RE: W.P. 58-59
Dunwich Twp. Bridge #9
District 2 - Hwy. 401

RE: Pile Load Tests
Currie Road Interchange Bridge
Highway 401, District 2
W.P. 58-59

Review of Preliminary Plan
No. D-4621-P1
by Foundations Office.

Re: Hwy. 401, Line 'A' & County Rd. Crossing
Dunwich Twp., Br. #9, District No. 2,
W.P. 58-59.

PILE LOADING TEST DETAILS

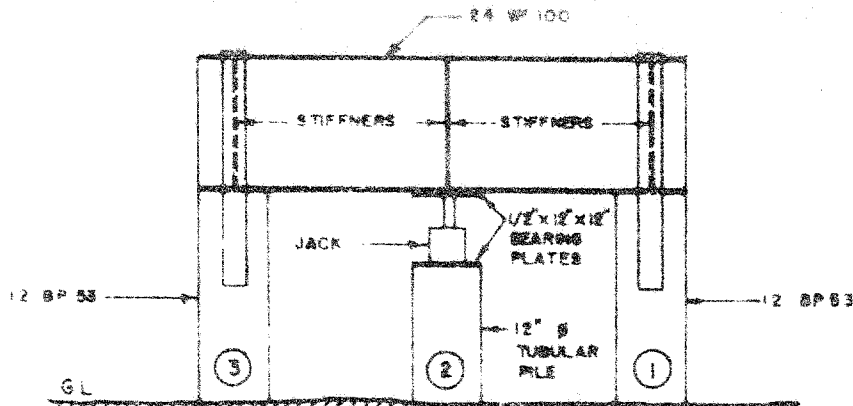
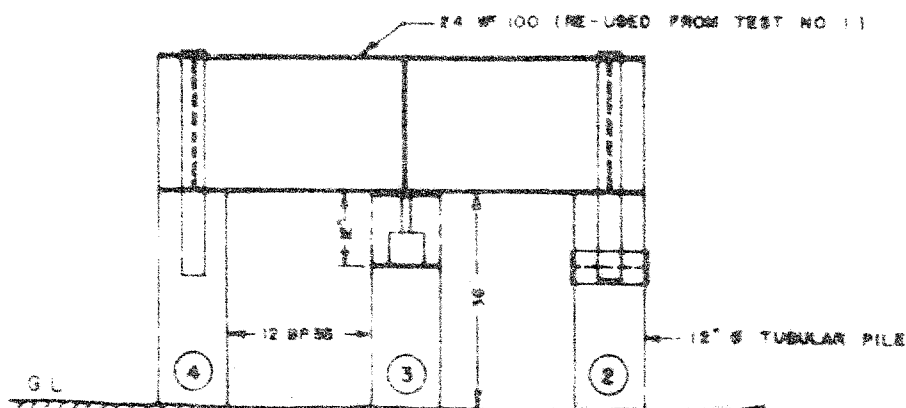
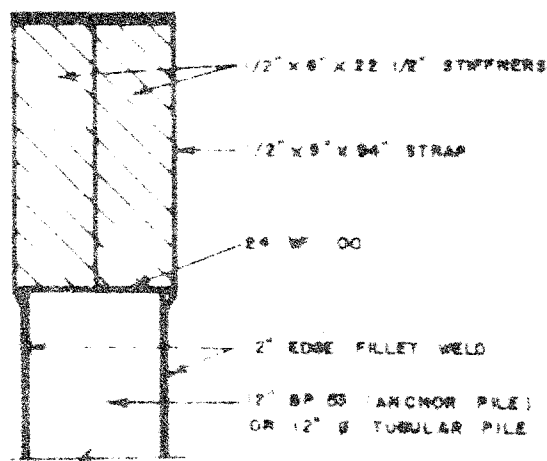
Testing will be carried out by using two adjacent piles as supports - i.e., anchors for the middle one which is tested. Attached to this memo, we are sending you a sketch showing the necessary arrangement of piles to be tested and the Bill of Materials. (Please ignore title of drawing.) We would appreciate

NOTE: For pile 2 an additional length of 1 ft. should be added.

For pile 3, the pile should be cut off approximately 2 ft. above ground.

DETAILED LAYOUT OF THE HORIZONTAL BEAM TO THE REACTION PILES.

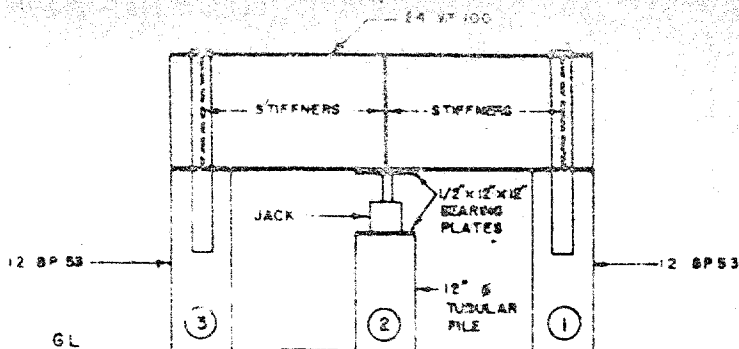
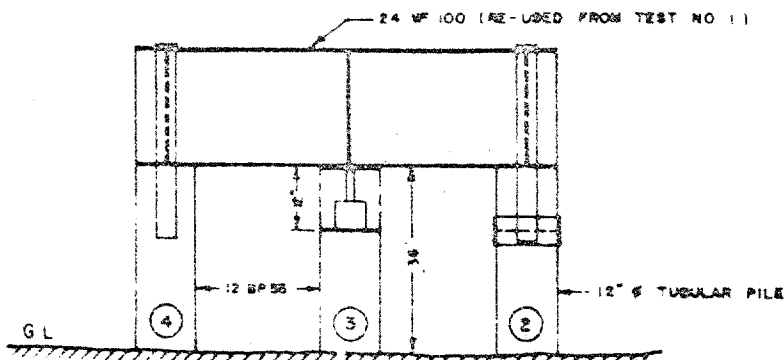
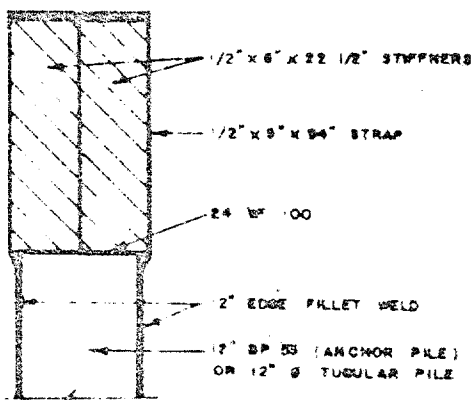
Testing will be carried out by using two adjacent piles as supports - i.e., anchors for the middle one which is tested. Attached to this memo, we are sending you a sketch showing the necessary arrangement of piles to be tested and the Bill of Materials. (Please ignore title of drawing.) We would appreciate

NOTE: For pile 2 an additional length of 1 ft. should be spliced.

PLAN & ELEVATION

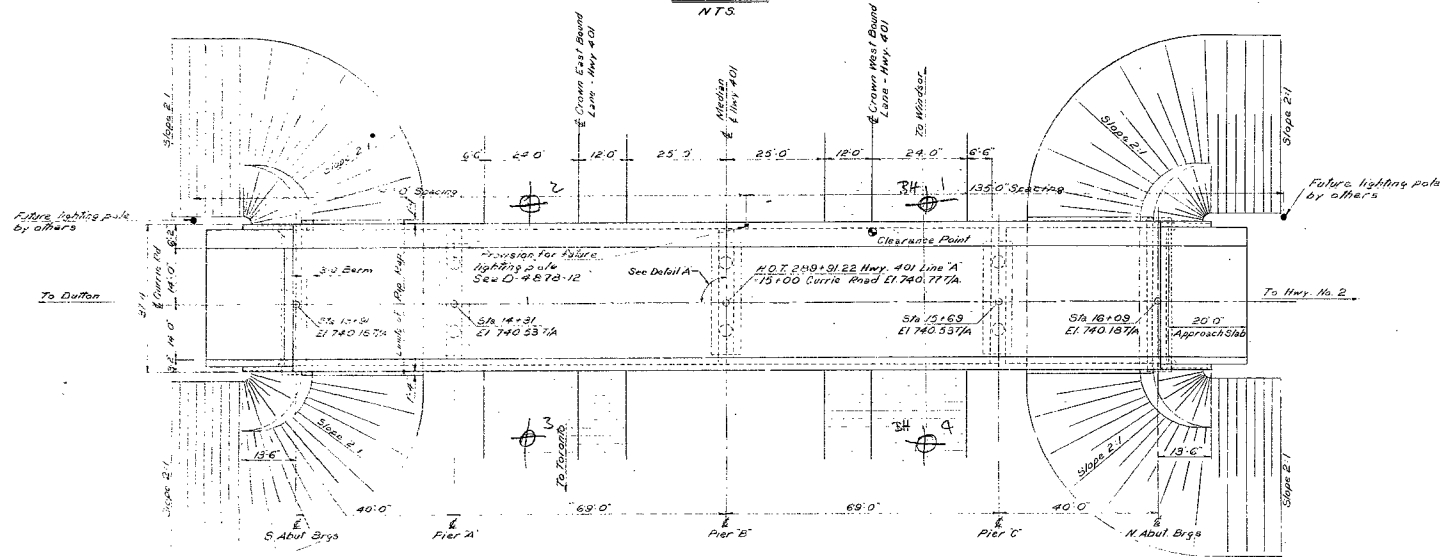
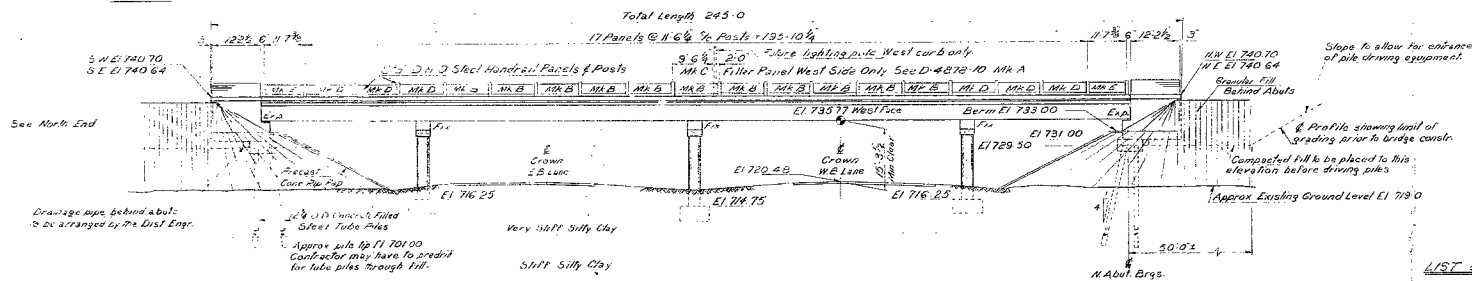
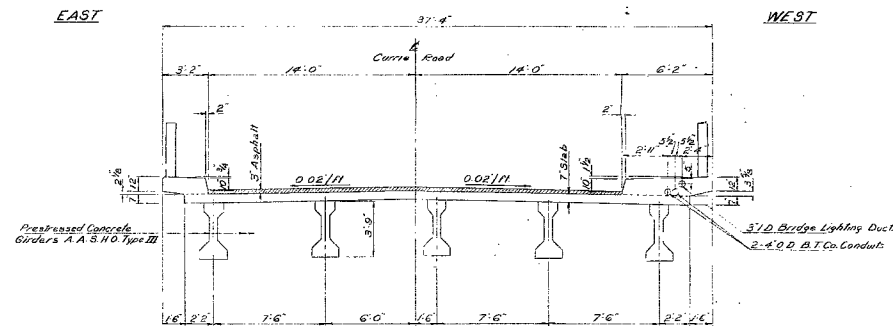
Please also indicate on the enclosed Drawing D 4878-1, the location where the test piles will be driven.

Note: This load test at the above location will not be carried out at the above mentioned location. This was decided by Mr Stermac of Foundation section and Mr Davis of Bridge office.
